UNITED STATES PATENT AND TRADEMARK OFFICE

APPLICATION NO.	FILING DATE	FIRST NAMED INVENTOR	ATTORNEY DOCKET NO.	CONFIRMATION NO.
10/802,519	03/16/2004	Dinesh Annayya	16820.P279	3972
7590 01/16/2007 Daniel E. Ovanezian BLAKELY, SOKOLOFF, TAYLOR & ZAFMAN LLP Seventh Floor 12400 Wilshire Boulevard Los Angeles, CA 90025-1026			EXAMINER CHAUDRY, MUJTABA M	
			ART UNIT	PAPER NUMBER
			2133	
SHORTENED STATUTORY PERIOD OF RESPONSE		MAIL DATE	DELIVERY MODE	
3 MONTHS		01/16/2007	PAPER

Office Action Summary	Application No.	Applicant(s)	
	10/802,519	ANNAYYA ET AL.	
	Examiner	Art Unit	
	Mujtaba K. Chaudry	2133

DETAILED ACTION

FIG. 3A

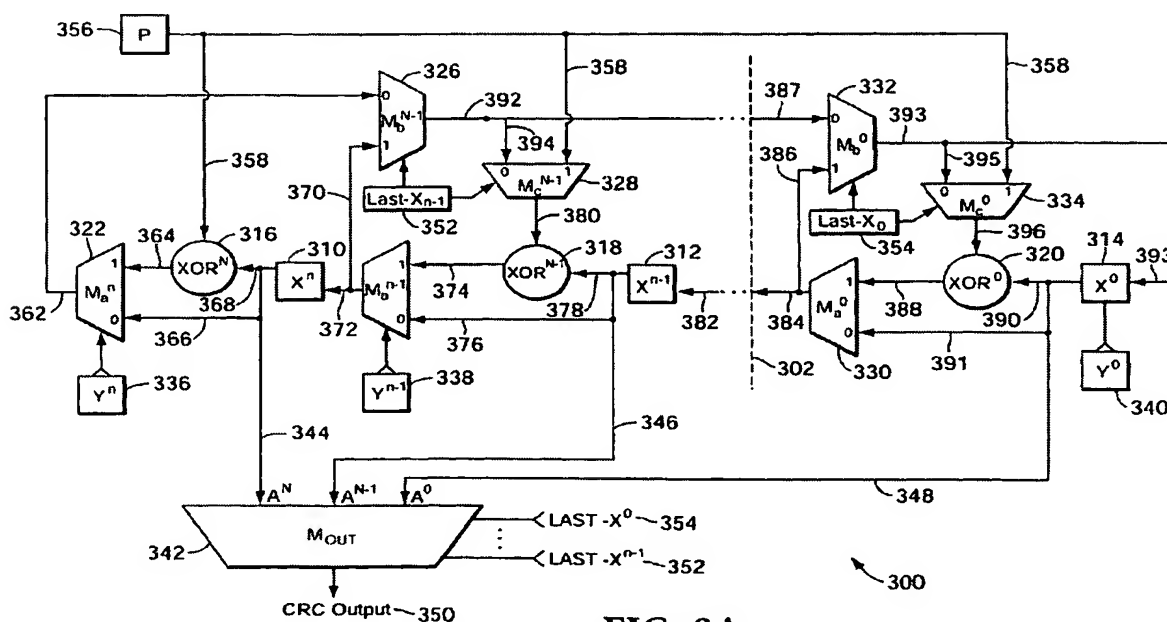
As per claim 1, Chen teaches an apparatus (i.e., title and paragraph 0002) comprising: a cycle redundancy check (CRC) calculator (i.e., Figure 3A and paragraph 0033); and a CRC nullifier coupled to the CRC calculator (i.e., Figure 3A, reference numbers 336, 338 and 340 & paragraphs 0011, 0052-0056). The Examiner would like to explain the interpretation of the CRC nullifier. In paragraph 0011 (lines 9-12), Chen teaches to nullify a subset of the shift registers used in the CRC generator. Further in paragraphs 0052-0056, Chen performs the nullification process by programmable registers Y which are shown in Figure 3A and referred to by reference numbers 336, 338 and 340. Particularly, in paragraph 0055 (lines 5-9) Chen explains the nullifier by determining which of the coefficients take the value of 0.

As per claim 2, Chen teaches, in view of above rejection, the CRC nullifier is one of a plurality of nullifiers (i.e., Figure 3A, reference numbers 336, 338 and 340), each having an output (i.e., Figure 3A, reference numbers 336, 338 and 340 have an output), and wherein the apparatus further comprises an output multiplexer (i.e., Figure 3A, reference number 342) coupled to the plurality of CRC nullifiers to select the output of one of the plurality of CRC nullifiers. The Examiner would like to point out that the output multiplexer is coupled to the nullifiers since, for example, the nullifier 338 is connected to control the output 372 and direct it to 310 which then relays it to the output multiplexer 342.

As per claim 3, Chen teaches, in view of above rejections, a data bus having N bytes (i.e., paragraph 0033, lines 2-4) coupled to the CRC calculator, wherein the plurality of CRC nullifiers comprise N-1 CRC nullifiers (i.e., Figure 3A, Y_0 to Y_{n-1} nullifiers).

As per claim 4, Chen teaches, in view of above rejections, a first multiplexer coupled to the CRC calculator (i.e., Figure 3A, reference number 326); and a second input multiplexer coupled to the CRC calculator (i.e., Figure 3A, reference number 332).

As per claim 5, Chen teaches, in view of above rejections, the first multiplexer (i.e., Figure 3A, reference number 326) is coupled to receive a data byte input signal (the input with reference number 370) and a feed zero signal (the input with reference number 362, which is the feed zero signal).

As per claim 6, Chen teaches, in view of above rejections, the second multiplexer (i.e., Figure 3A, reference number 332) is coupled to receive a default value input signal (input with reference number 387) and a CRC input signal (input with reference number 386).

As per claim 7, Chen teaches, in view of above rejections, the first multiplexer (i.e., Figure 3A, reference number 326) and the CRC calculator (i.e., Figure 3A, reference number 328) are each coupled to receive a byte enable signal (i.e., Figure 3A, reference number 352).

As per claim 8, Chen teaches, in view of above rejections, the CRC calculator performs a closed loop function (i.e., Figure 3A and paragraph 0059) and wherein the plurality of CRC nullifiers perform an operation outside of the closed loop function. The Examiner would like to point out that the nullifiers shown in Figure 3A (336, 338 and 340) operate outside of the closed loop function which only incorporates multiplexers 326, 328 and 324 (i.e., paragraph 0059).

As per claim 13, Chen teaches, in view of above rejections, performing a closed loop calculation function using the CRC calculator (i.e., Figure 3A, reference numbers 324, 326 and 328 and paragraph 0059); and performing a nullification function outside of the closed loop

calculation function using at least one nullifier (i.e., Figure 3A, reference number 338) of a plurality of nullifiers (i.e., Figure 3A, reference numbers 336, 338 and 340). The Examiner would like to point out that the nullification process is outside of the loop comprising of, for example, multiplexers 324, 326 and 328 (i.e., paragraph 0059).

As per claim 20, Chen teaches, an apparatus (i.e., Figure 3A and paragraph 0002) comprising: means for performing a closed loop calculation function using cycle redundancy check (CRC) calculator (i.e., Figure 3A, reference numbers 324, 326 and 328 and paragraph 0059); and means for performing a nullification function outside of the closed loop calculation function using a nullifier (i.e., Figure 3A, reference numbers 336, 338 and 340 and paragraphs 0052-0055). The Examiner would like to point out that the nullification process is outside of the loop comprising of, for example, multiplexers 324, 326 and 328 (i.e., paragraph 0059). Also, the Examiner would like to explain the interpretation of the CRC nullifier. In paragraph 0011 (lines 9-12), Chen teaches to nullify a subset of the shift registers used in the CRC generator. Further in paragraphs 0052-0056, Chen performs the nullification process by programmable registers Y which are shown in Figure 3A and referred to by reference numbers 336, 338 and 340.
